PREVOST

WARRANTY BULLETIN

WB23-34

DATE:	December 2023	SECTION:	06 ELECTRICAL
EXPIRATION:	December 2025		
SUBJECT:	ENGINE ACCESSORIES HARNESS MODIFICATION

REPLACE SPLICES WITH A CONNECTOR

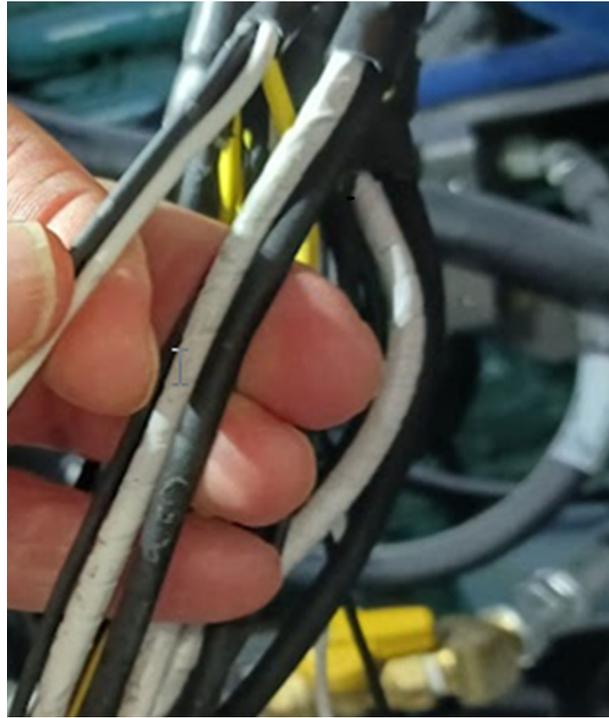
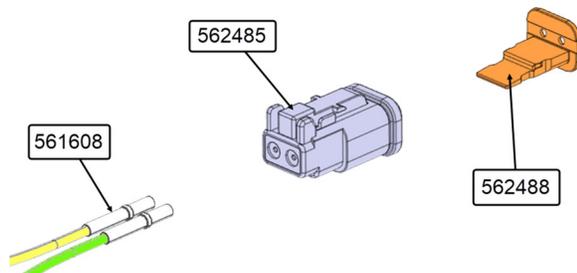
On the vehicles affected by this bulletin the engine accessories harness needs a modification to avoid oxidation.

1. Remove the splice.

2. Crimp terminal 561608 (2x) on each wire of the harness.
3. Insert terminals into connector 562485.
4. Secure terminals into the connector with secondary lock 562488.

ASSEMBLY OF JUNCTION CABLE

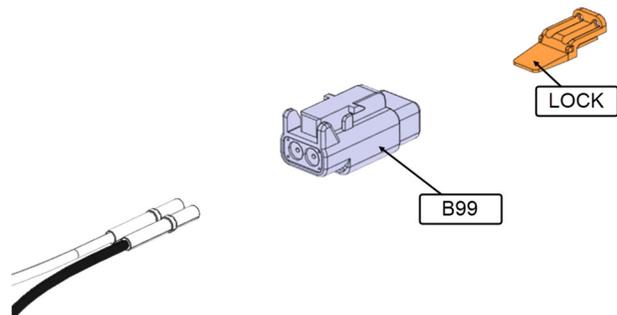
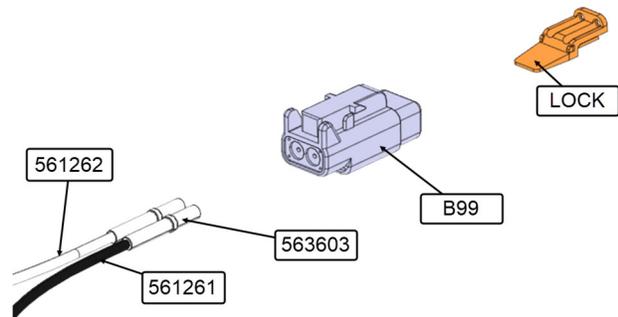
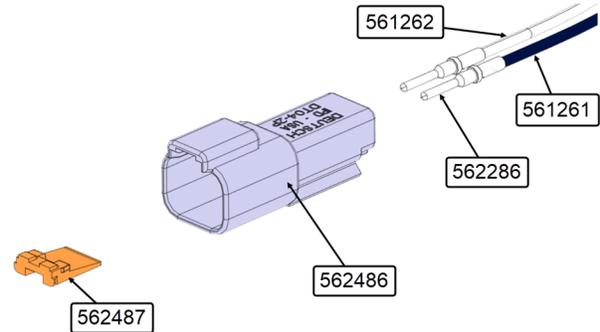
1. Remove existing connector B99 and discard wires with the splice.

2. Crimp terminal 563603 (2x) on each wire of 561261 and 561262.
3. Insert terminals into the connector B99.
4. Secure terminals into the connector with secondary lock.
5. Twist wires before installing the other end.

6. Crimp terminal 562286 (2x) on each wire of 561261 and 561262.
7. Insert terminals into the connector 562486.
8. Secure terminals into the connector with secondary lock 562487.
